Your Ref
M/26/15/HH
Our Ref
PLAN-009373
Date
15/04/2015

Proposal: Demolition of rear conservatory with new rear extension.
Site: 1, West Avenue, Middleton on Sea, PO22 6EF
M/26/15/HH

Screen Print

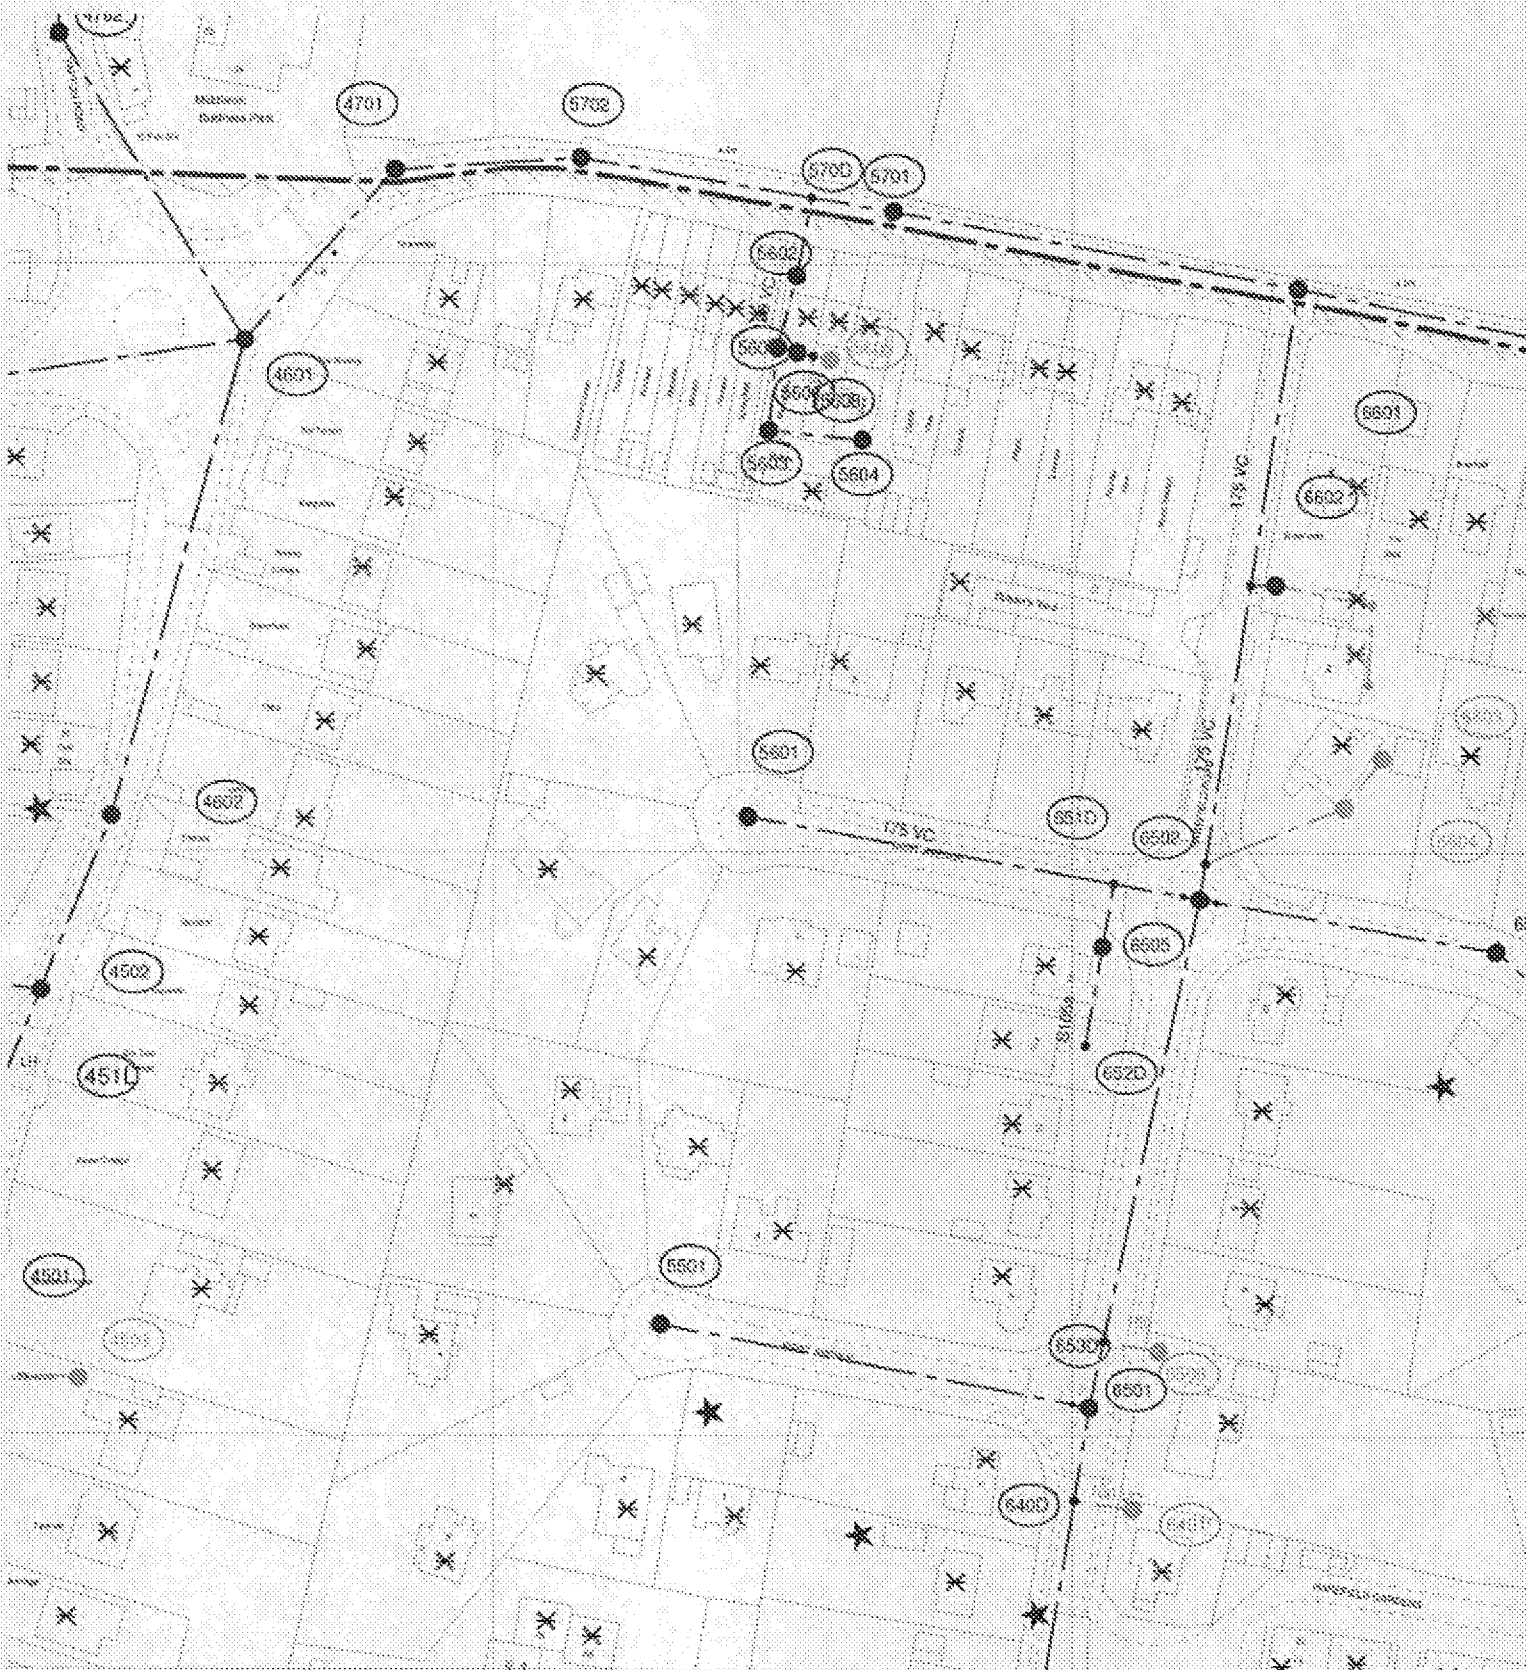
Due to changes in legislation that came in to force on 1st October 2011 regarding the future ownership of sewers it is possible that a sewer now deemed to be public could be crossing the above property. Therefore, should any sewer be found during construction works, an investigation of the sewer will be required to ascertain its condition, the number of properties served, and potential means of access before any further works commence on site. The applicant is advised to discuss the matter further with Southern Water, Sparrowgrove House, Sparrowgrove, Otterbourne, Hampshire SO21 2SW (Tel: 0330 303 0119) or www.southernwater.co.uk".

WARNING: RAC pipes are constructed of Rigid Asbestos Cement
WARNING: Unknown (UNK) materials may include Rigid Asbestos Cement
